**TransGrid Revised Revenue Proposal 2018-23**

**Review of aspects of TransGrid's  
revised forecast capital  
expenditure**

**Australian Energy Regulator**

**Energy Market Consulting associates**

Figure 2: Capital expenditure versus cumulative annual risk savings

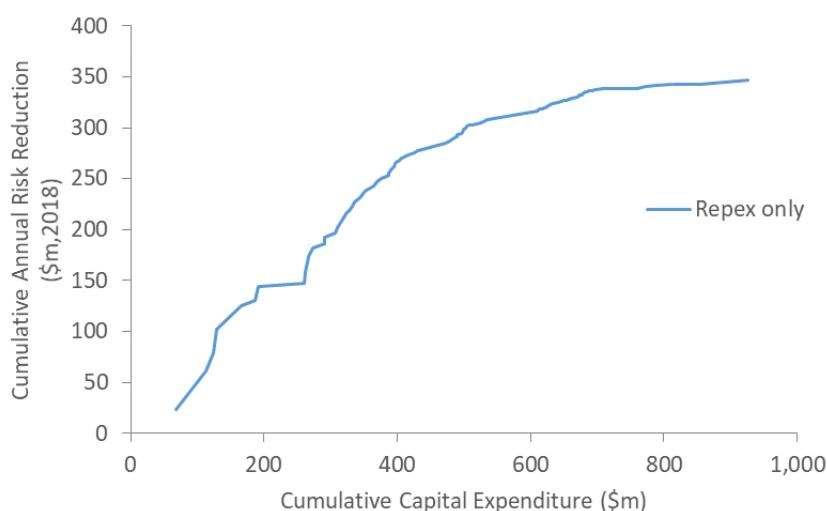
107. In our initial RP report, we stated that we observed an *(a)bsence of a rigorous top-down challenge to (TransGrid's) portfolio*<sup>41</sup>. Absent such evidence, we sought information from TransGrid through an information request, and we produced Figure 16 in that report as an illustration of the kind of portfolio assessment that can be helpful. TransGrid has presented a corrected and updated version of this graph, as Figure 4.4 in its RRP.

108. TransGrid has provided updated data to us in response to further Information Requests<sup>42</sup>, and we have used this data to facilitate further top-down review. The revised data is presented in the figure below. While the updated scale helps with interpretation of this data, the message is essentially the same as we stated in our initial RP report, namely that *'...the cumulative risk cost savings flattens for increasing capex'* and that *'.... the general shape of the relationship suggests that there may be an opportunity to test that the level of capex is optimised.'*<sup>43</sup>

Figure 3: Cumulative Repex versus NPV

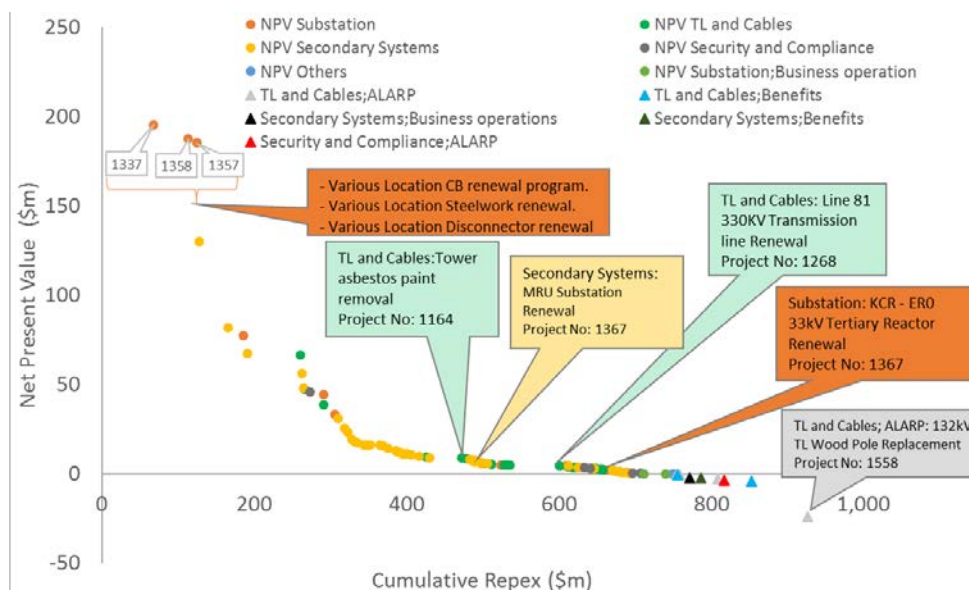
109. We undertook further analysis to plot the NPV of the portfolio against the cumulative repex, with projects sorted in diminishing NPV.

111. We consider that an effective governance process would have involved identification and more detailed scrutiny of projects at the marginal end of the spectrum and a realistic appraisal of the risk cost implications of incremental and decremental investment levels relative to the proposed program. We have not been provided with evidence of such a process. This leads us both to apply greater scrutiny of the large element of proposed expenditure that appears to provide marginal benefit; secondly, it indicates to us that if TransGrid was to incur a materially lower repex than it has proposed, the risk cost outcome would not be significantly higher.

Figure 4: Project timing optimisation - illustration

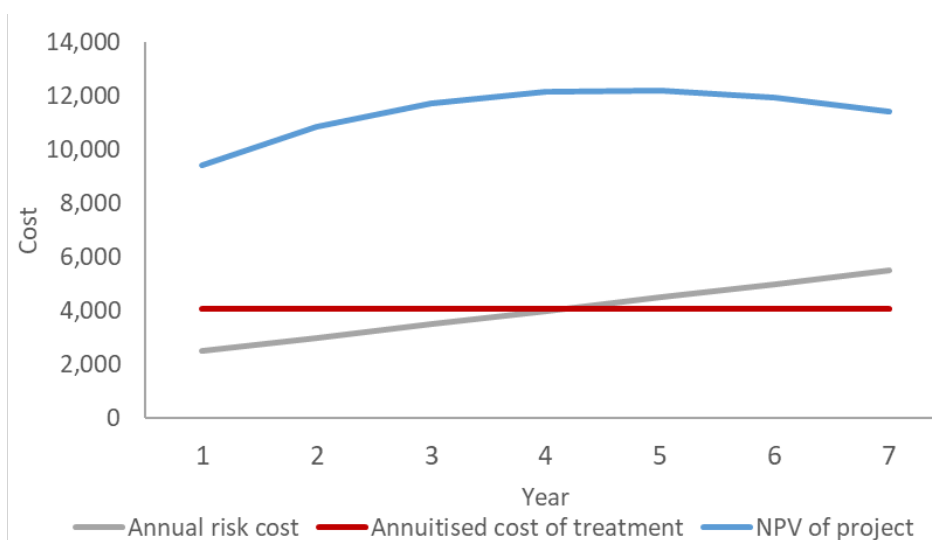
125. We refer to the following diagram, which is conceptually similar to that which TransGrid has provided in Figure 4.16 of its RRP. The blue line shows the NPV of an illustrative project, which is plotted above the annuitised risk cost of treatment and an annual risk cost (which is assumed to rise over time). The maximum NPV is obtained if the project is undertaken in the year in which the annual risk cost first exceeds the annuitized cost of treatment – which in this case is around year 4. However, importantly, the project does have a positive NPV even if it is undertaken prior to this optimum timing.

126. TransGrid's Figure 4.16 similarly shows a positive NPV (though not the 'maximum NPV) if the project in its illustration is undertaken prior to the optimum year (being year 3 in its example).
